REGULAR MEETING – PLANNING AND ZONING COMMISSION AGENDA

APRIL 16, 2025, 6:00 PM

- G. #2024-65 SPR/CAM - Hyde Park Properties, LLC - 71 Water Street and 25 Elizabeth Street (District 2, Block 44, Lots 14 and 13) - Coastal site plan review application for the construction of a six-story, 32-dwelling unit, mixed-use building - Report & recommended action**

Re: Response to Preliminary Review Comments
Application #2025-14 CAM
5 Outer Road, Norwalk, CT

1 Section thru AC condenser screen

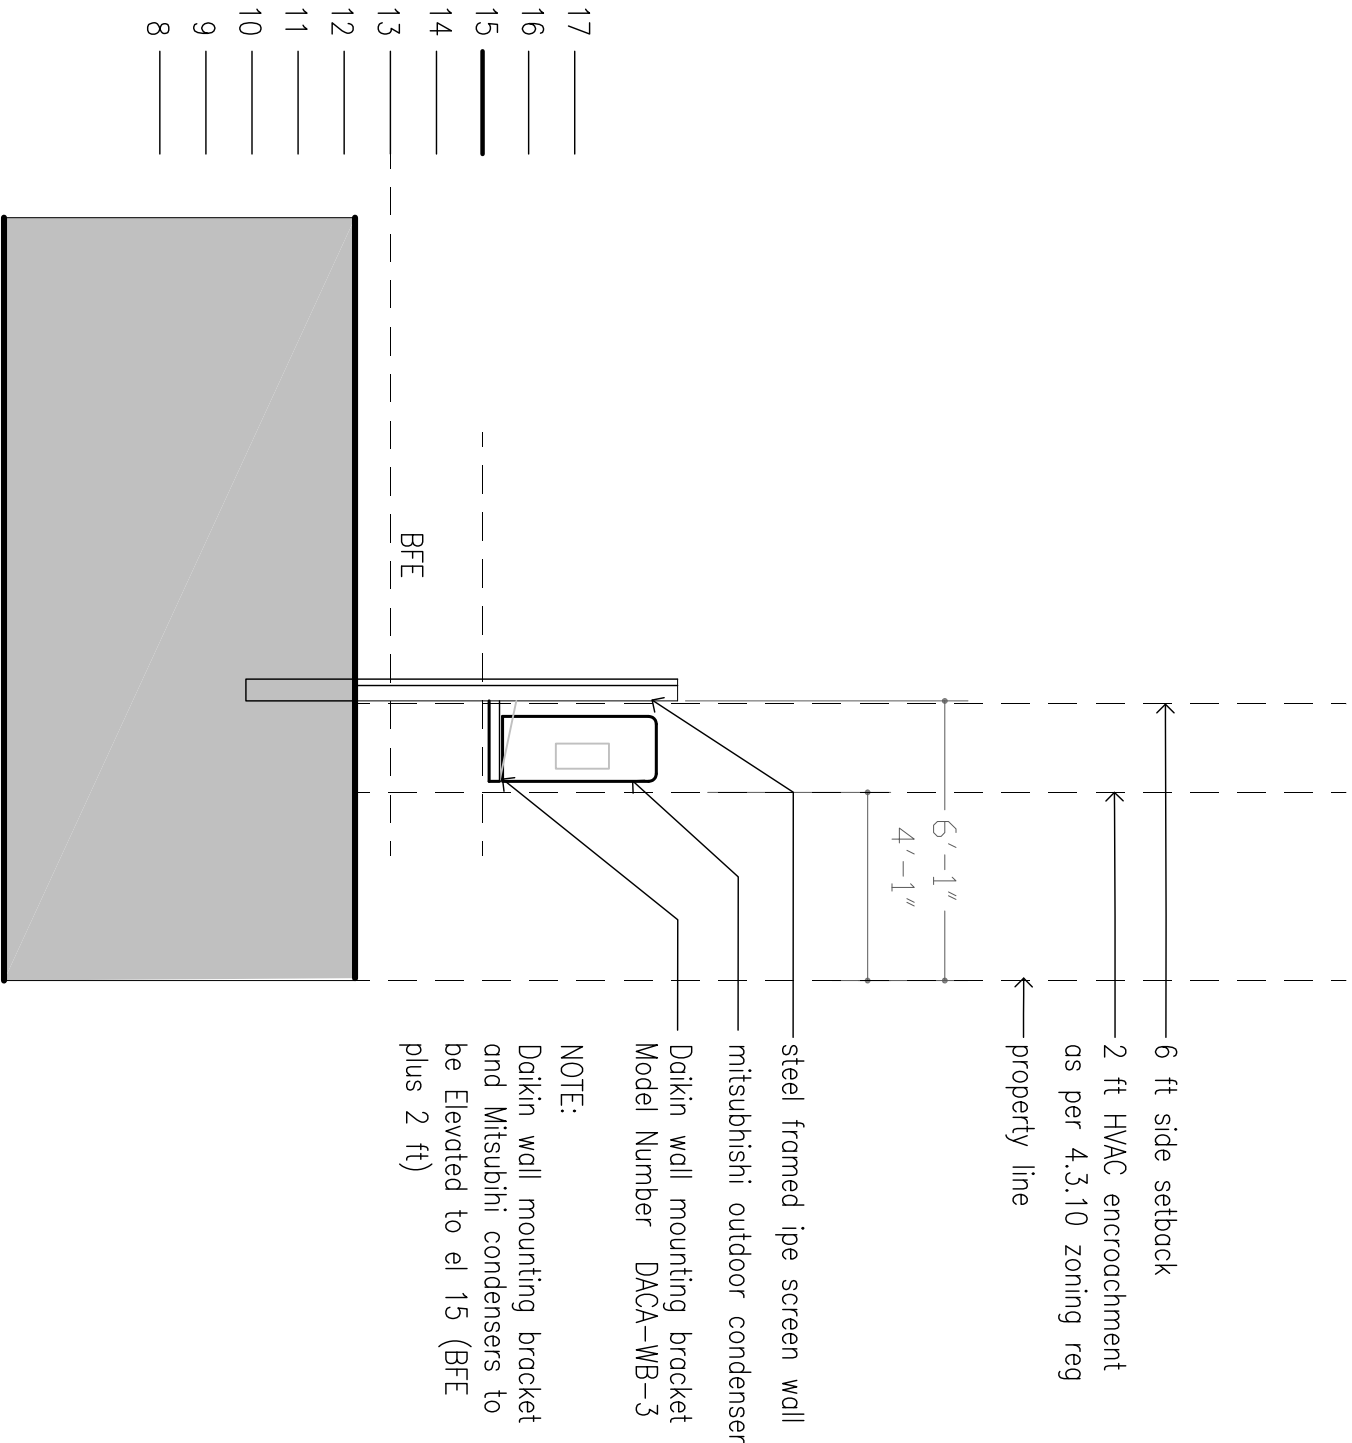
- 11) *The platform for the A/C units must comply with setbacks and is not allowed an encroachment. The plan indicates the platform will be raised to an elevation of 13' - please be advised that the bottom of all mechanicals including HVAC must be raised to at least 2' above the 13' BFE.*

RESPONSE: The platform for the A/C units has been removed. Instead the units will be mounted on a reinforced fence in approximately the same location. It is our understanding that the Zoning Regulations allow for mechanical equipment to encroach 2' into the yard setback. The bottom of the A/C units has been raised to elevation 15.0, which is 2' above the BFE.
